CITY OF ALBUQUERQUE

RE: **Albuquerque School of Excellence
6316 Tesuque NW
Grading and Drainage Plan
Engineers Stamp Date 5/15/2020 (E10D077)**

GRADING AND DRAINAGE PLAN

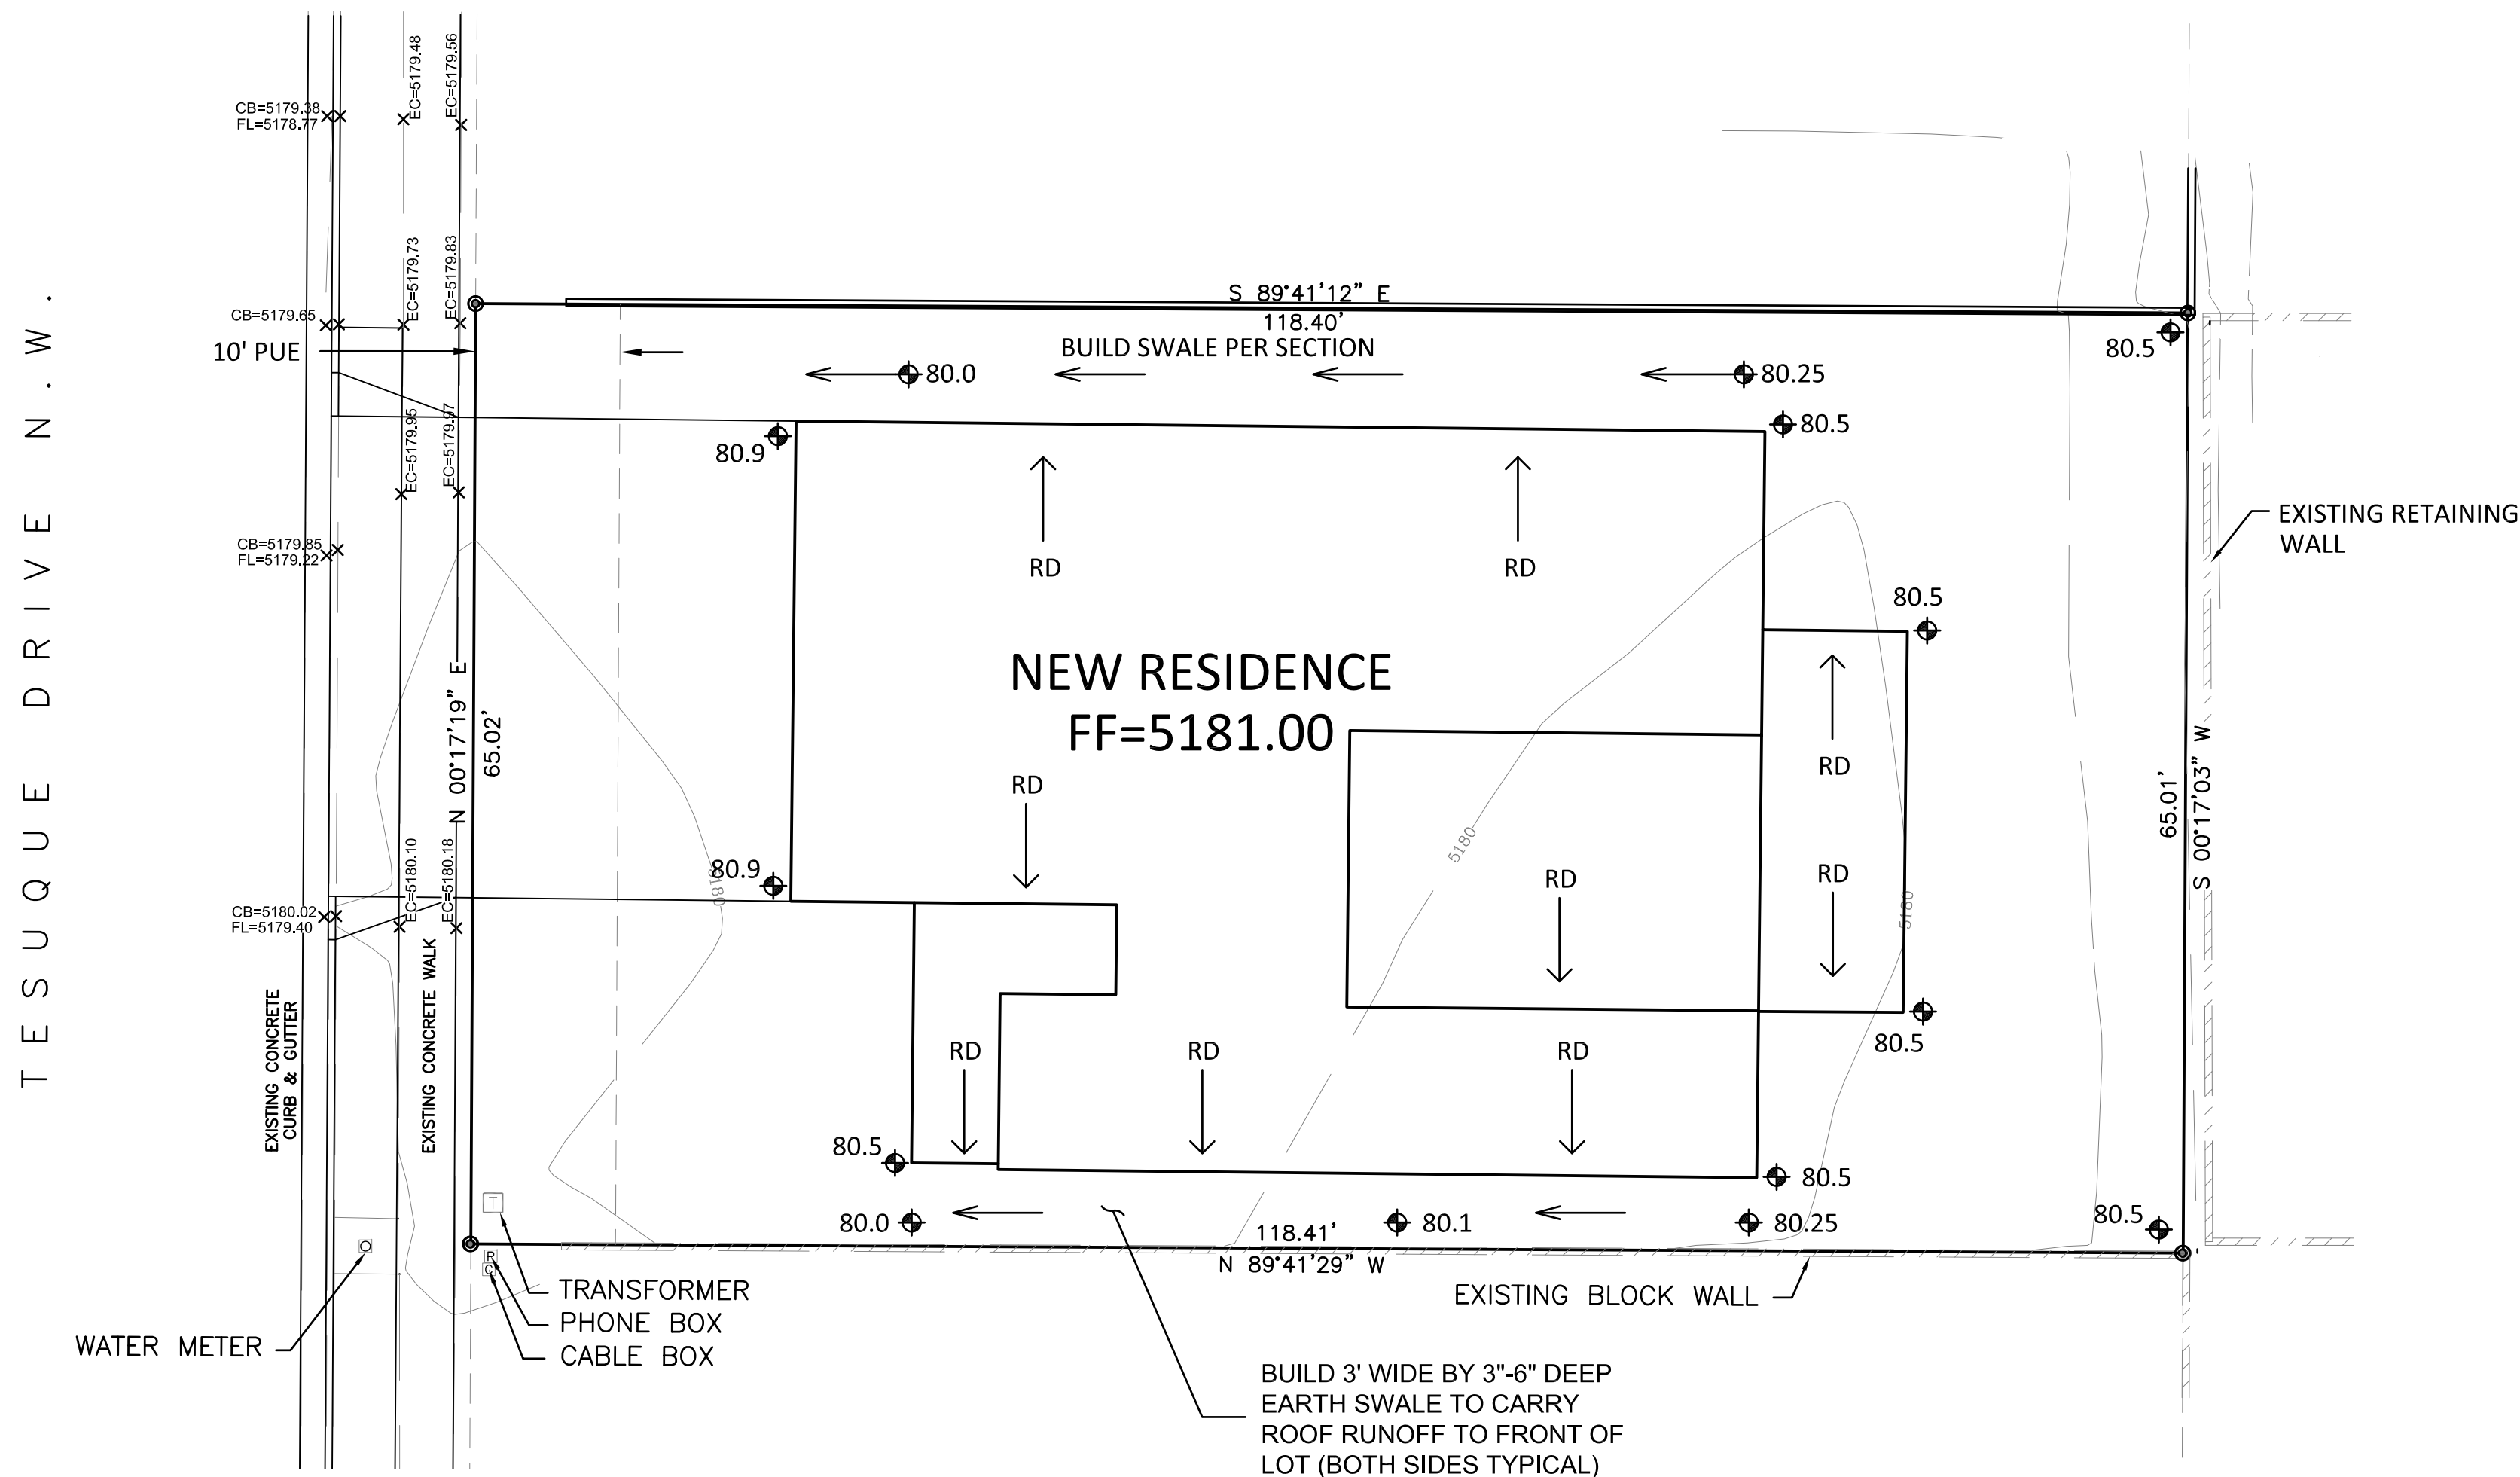
Based upon the information provided in your submittal received 5/18/2020, this plan is approved for Grading.

Prior to Building permit approval a Pad Certification will be required, provided by the Engineer or a registered Land Surveyor.

Advise the owner contractor not to use dirt as a ramp to climb the curb, use lumber or crusher fines for this purpose.

Reiterate to the Owner/Contractor that a separate permit for a garden/retaining wall must be obtained with the approved G&D plan and Pad Certification. Also, if a swimming pool is to be placed the grading and drainage plan will change and will need to be resubmitted.

Prior to Certificate of Occupancy release, Engineer Certification per the DPM checklist is required.
